CHATHAM COUNTY PURCHASING & CONTRACTING DEPARTMENT

ADDENDUM NO. 2 TO 18-0115-4

FOR: BENTON BOULEVARD EXTENSION

Bid No. 18-0115-4
BENTON BOULEVARD EXTENSION
PRE-BID QUESTIONS – Addendum 2

TYPICAL SECTIONS

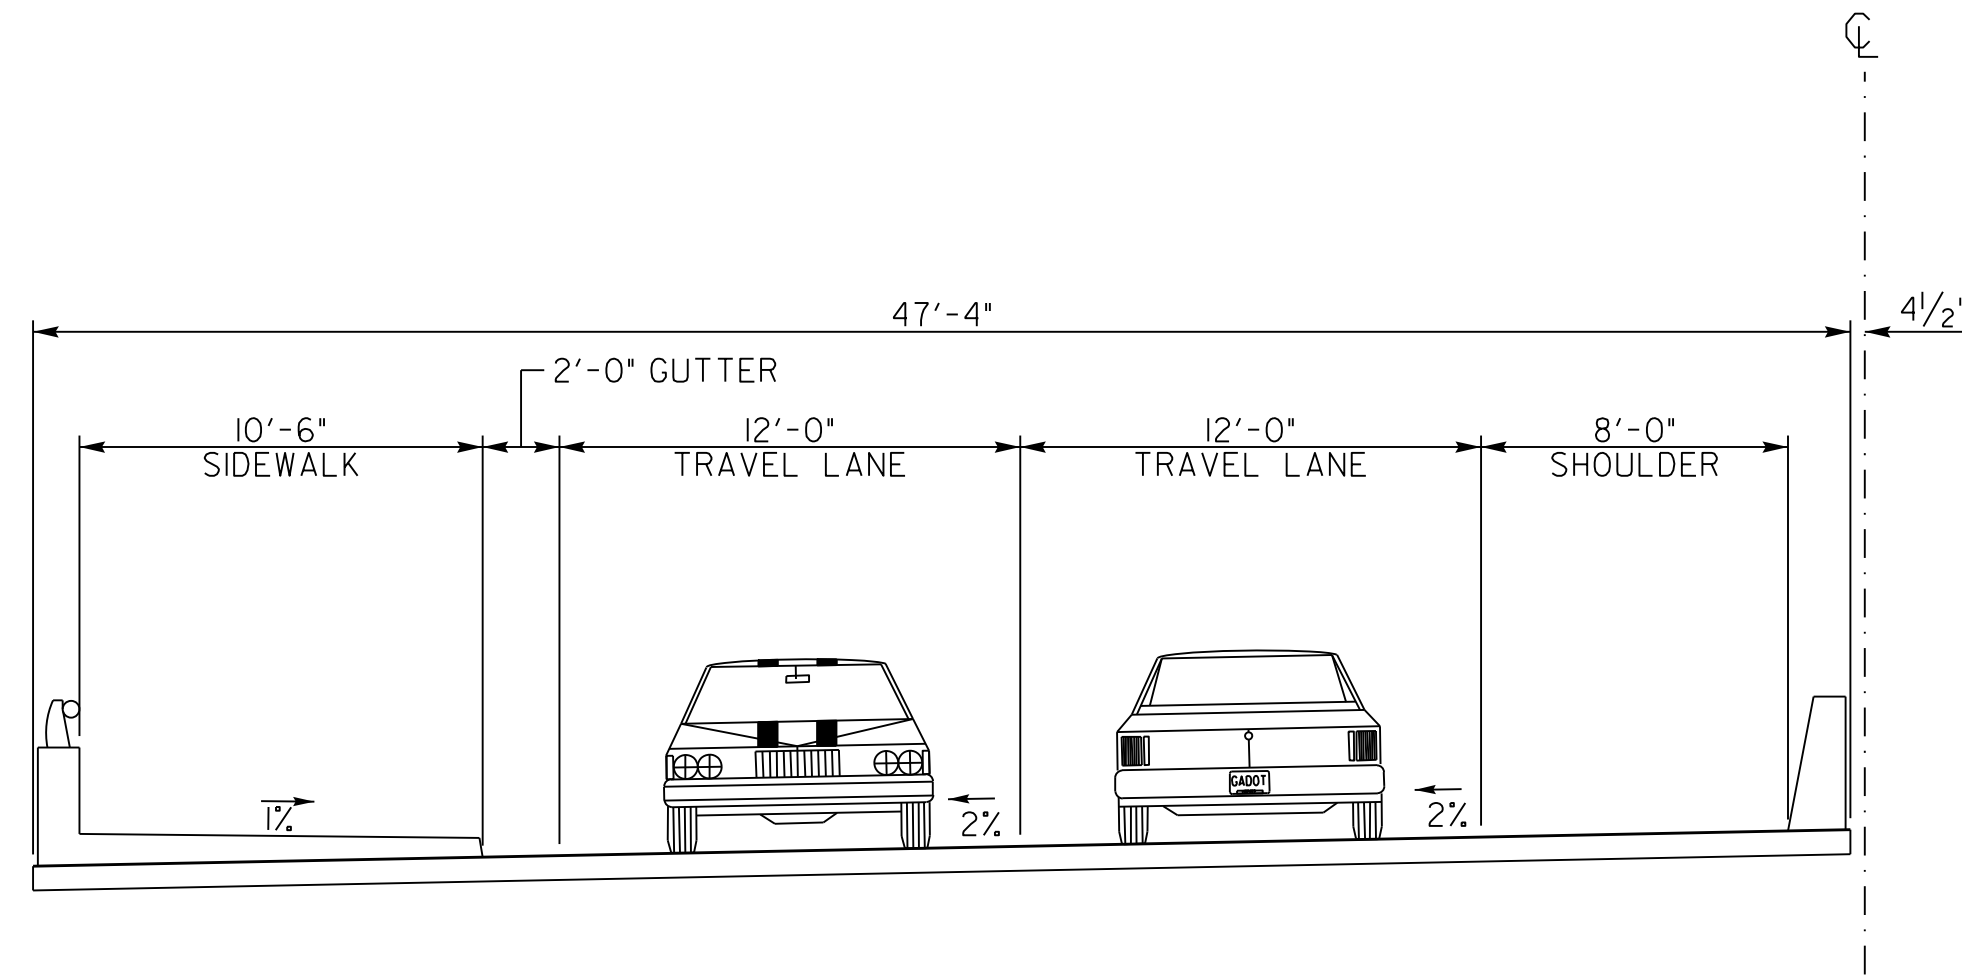
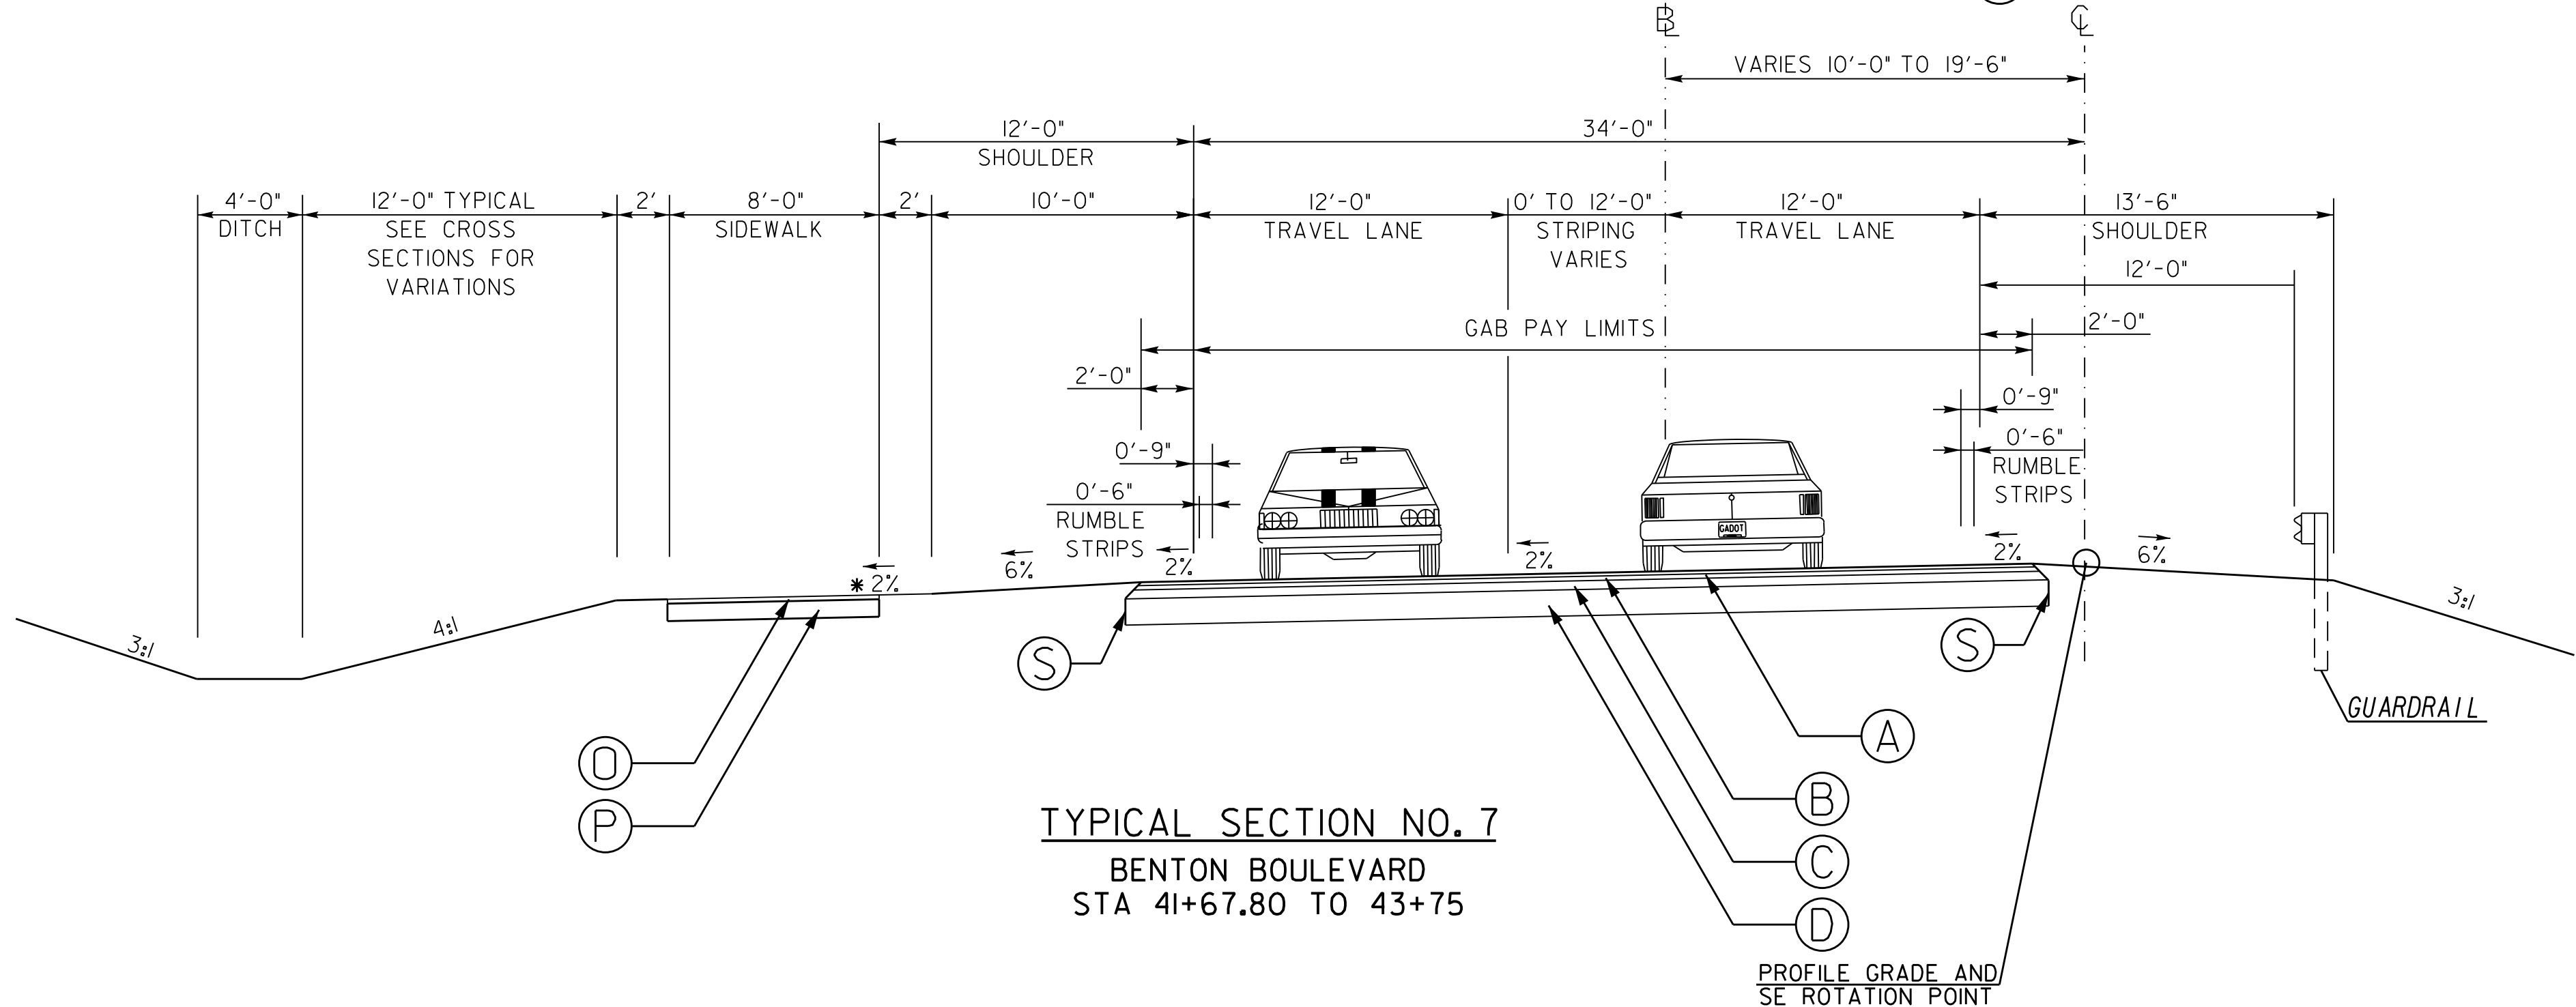
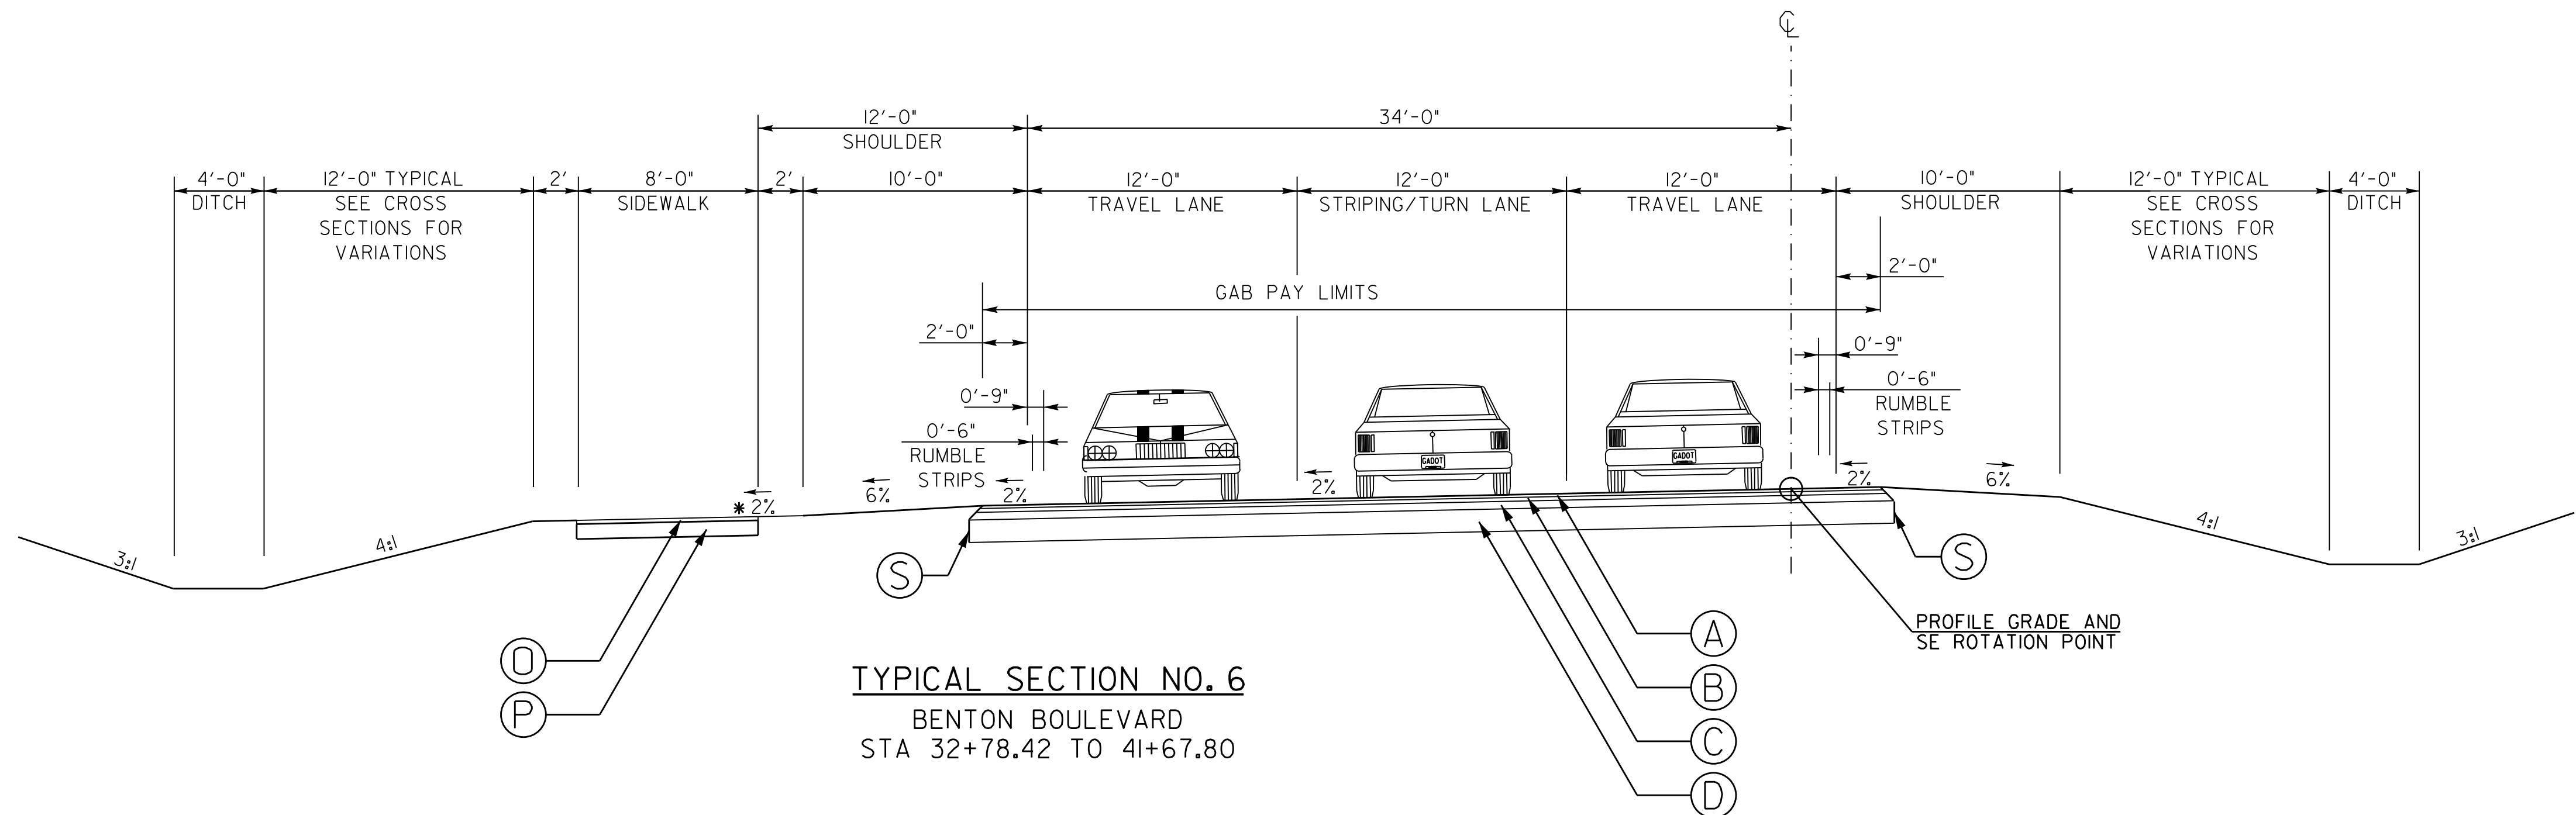
1. Revised typical sections will be provided with 12.5mm asphalt for the asphalt sidewalk. See Revised plan sheets.

220 LB/SY RECYCLED ASPH CONC 12.5MM SUPERPAVE, GROUP 2 ONLY, INCL BITUM MATL & H LIME
